VOGTLE ELECTRIC GENERATING PLANT
REQUEST TO REVISE TECHNICAL SPECIFICATIONS
REVISION TO REACTOR PRESSURE LIMITS

MARKED UP TECHNICAL SPECIFICATION PAGES

VOGTLE ELECTRIC GENERATING PLANT REQUEST TO REVISE TECHNICAL SPECIFICATIONS REVISION TO REACTOR PRESSURE VESSEL LIMITS

EXEMPTION REQUEST

FIGURE B 3/4.4-1

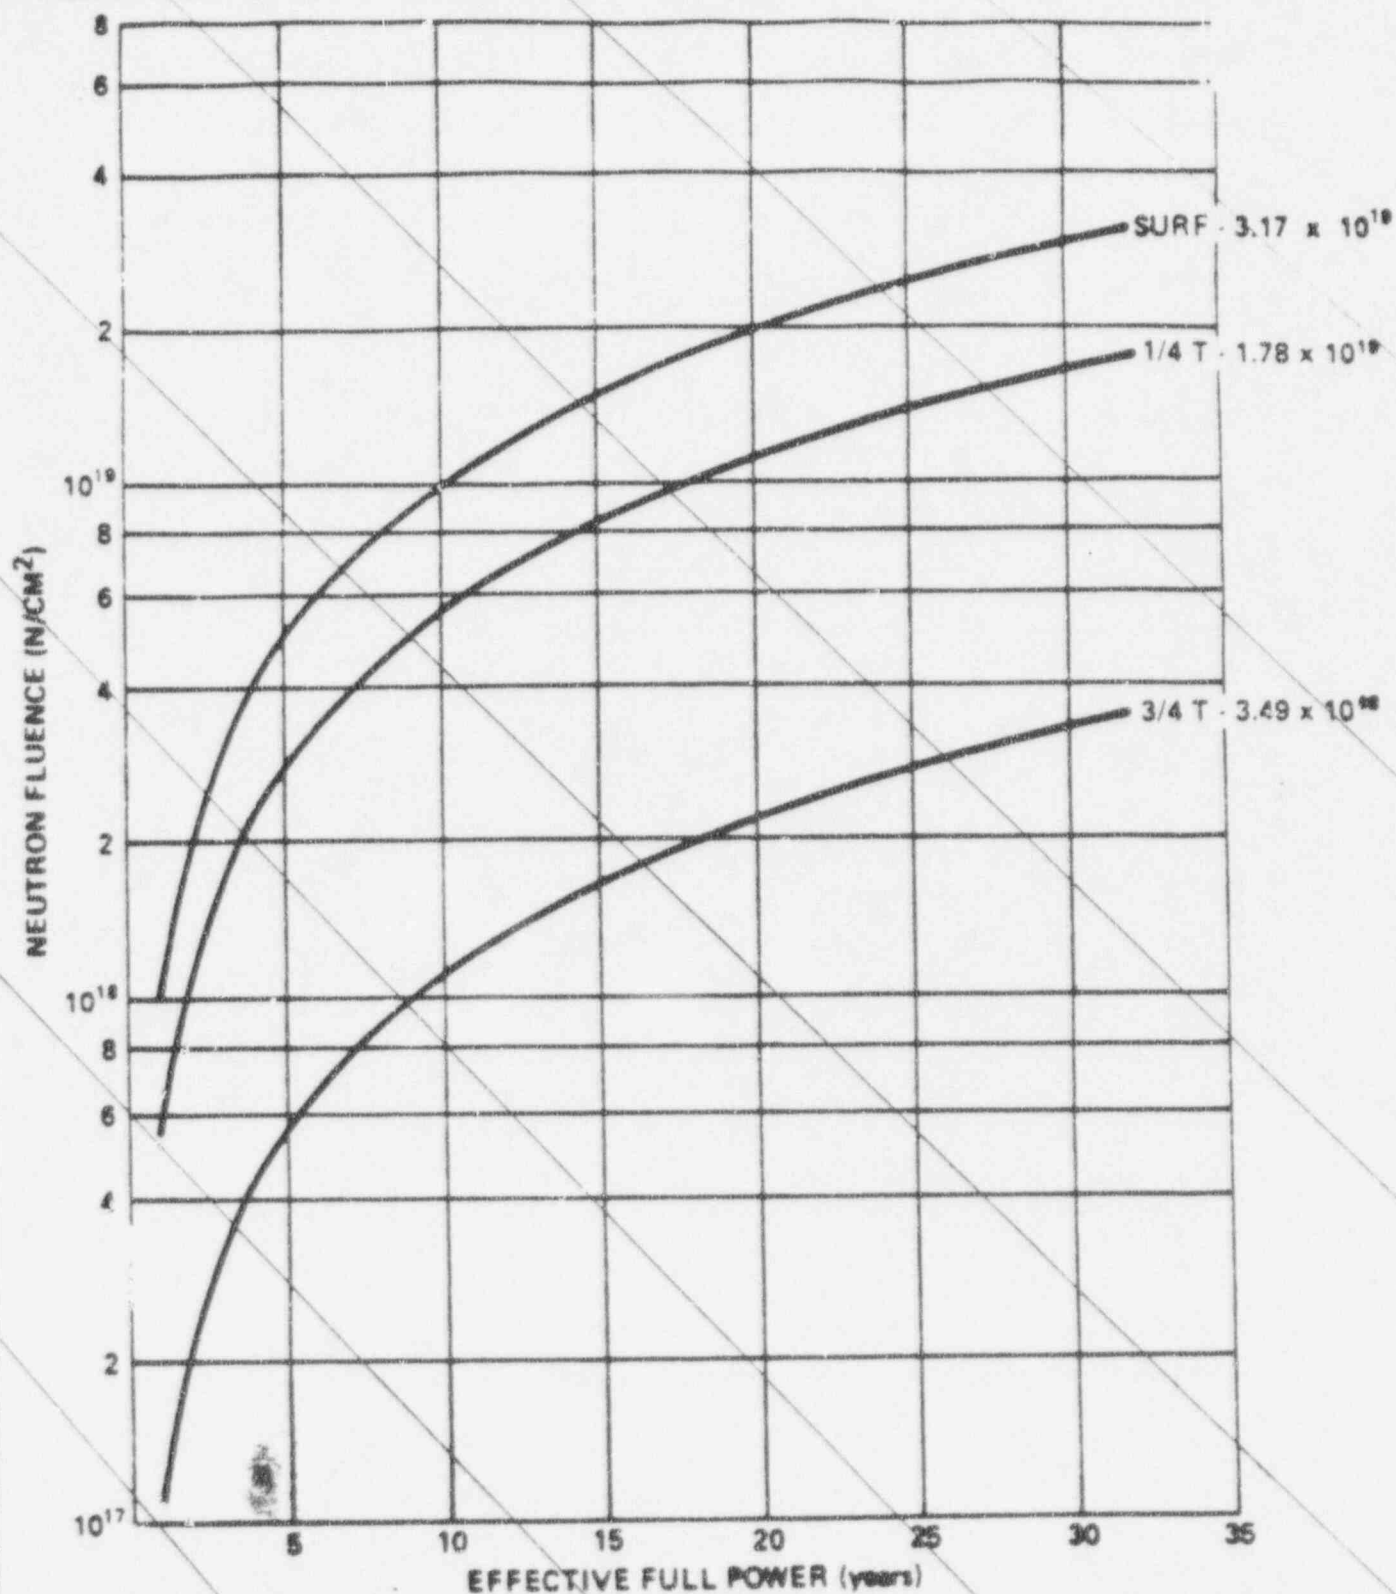
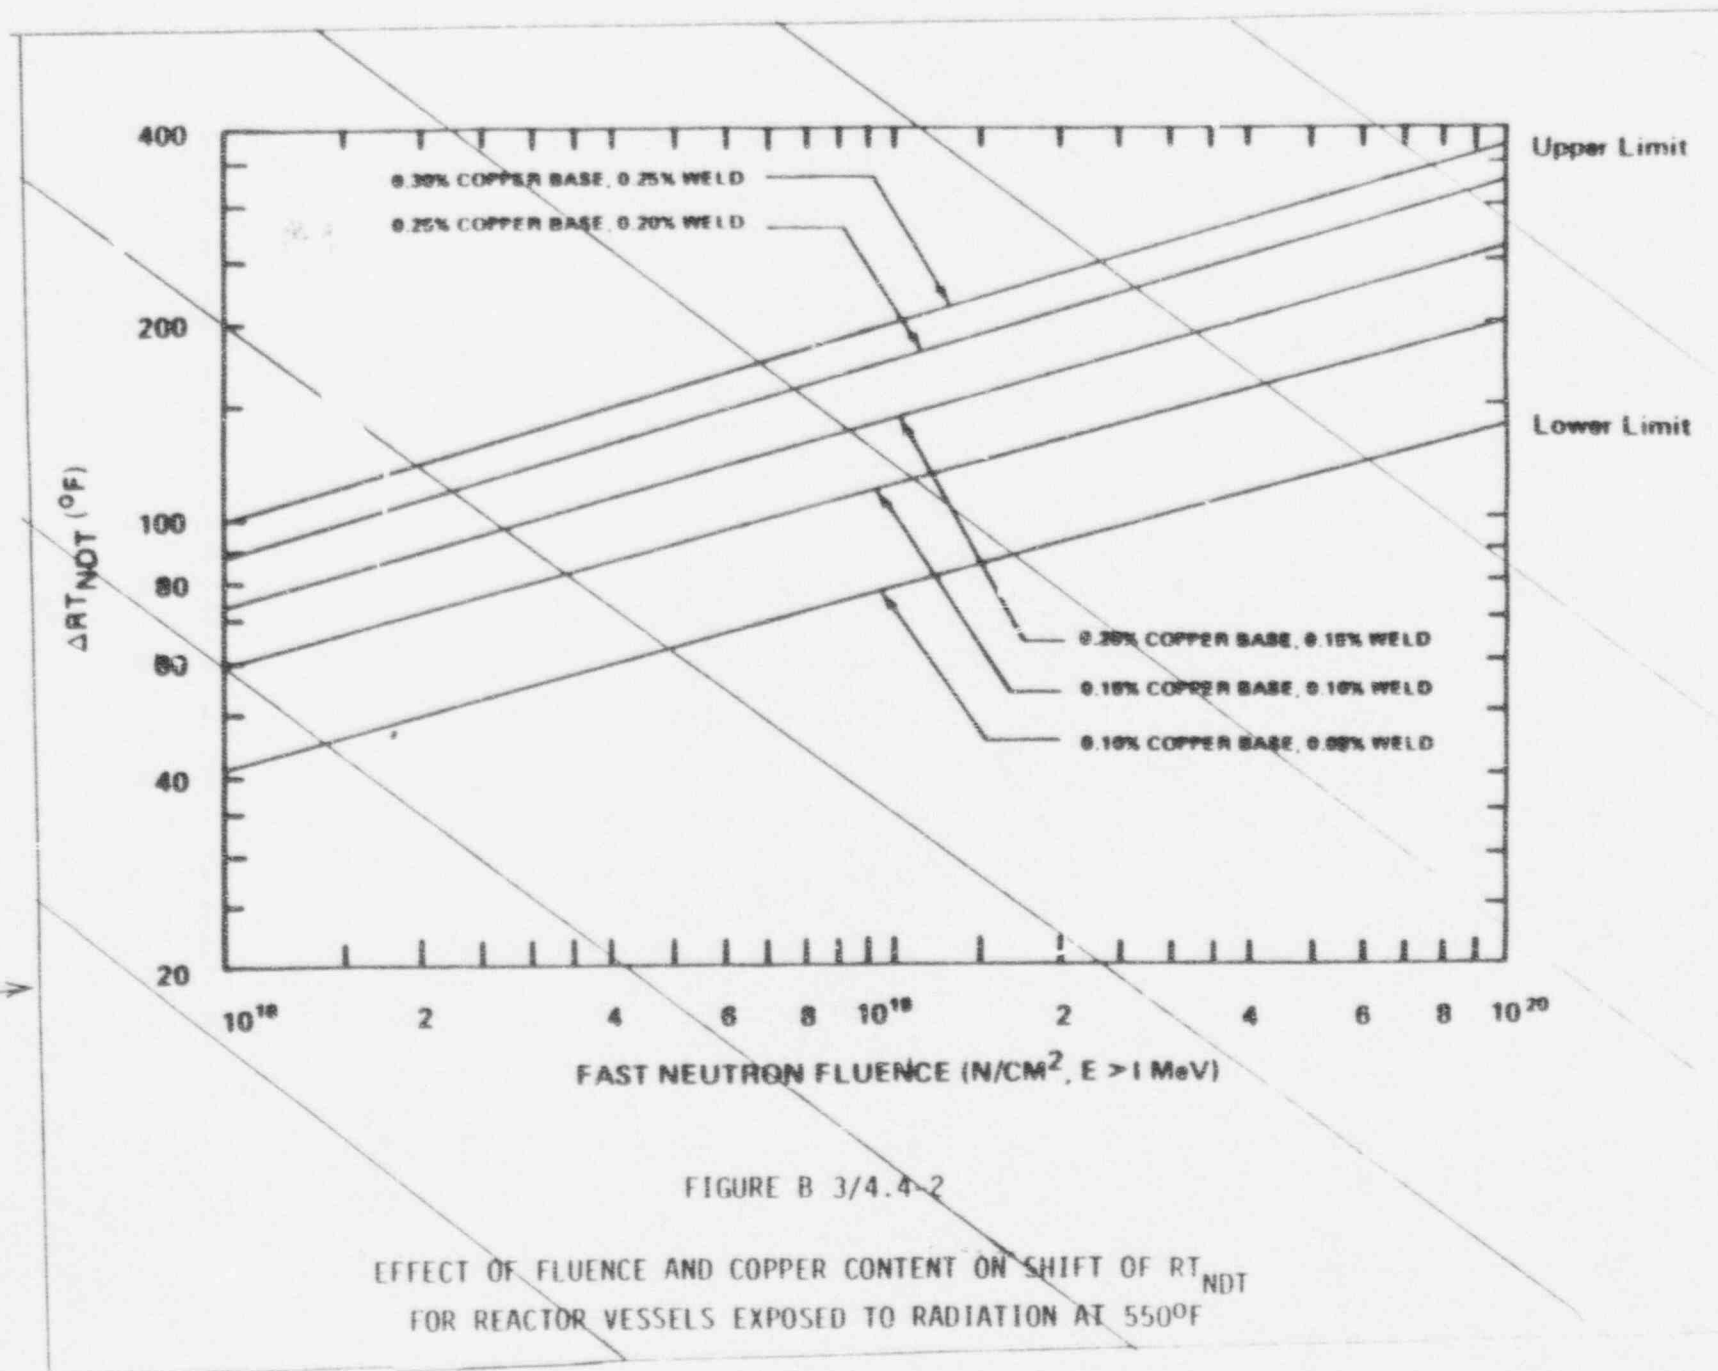
DELETE
